# Product Change Notification

<b>Date Issued :</b>	June 10, 2022	<b>PCN Number :</b>	512203
<b>Reason for Change :</b>	Capacity change or tool replacement		
<b>Description of Change :</b>	This notice is to inform you that Molex Lincoln Nebraska is adding additional tooling that will affect the product listed. New tooling will be exact replica of current tooling. There will be no change to the product Fit, Form, Function or Appearance when compared to current tooling.		
<b>Reason for Short Notice :</b>	Capacity Increase		
<b>Assessment of Change :</b>	First Article Inspection		
<b>Planned Implementation Date :</b>	August 31, 2022		
<b>Sample Availability Date:</b>	August 17, 2022		
<b>Internal Molex Qualification Date :</b>	August 03, 2022		
<b>Last date to request Samples by Customer :</b>	August 24, 2022		
<b>Traceability Code Markings / Date :</b>	Product made after planned implementation date can contain the change

- 200488 Series
  - Mini-Fit Sigma Plug Housing

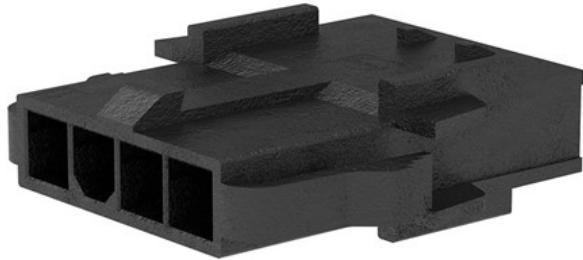
- To ensure business continuity, another set of tooling is being added
  - New tooling will be an exact replica of current tooling
  - Tooling being added to keep up with current and future demand
- There is NO impact to Fit, Form or Function
- Samples available upon request after date shown above
- Part Numbers Impacted
  - See attached list
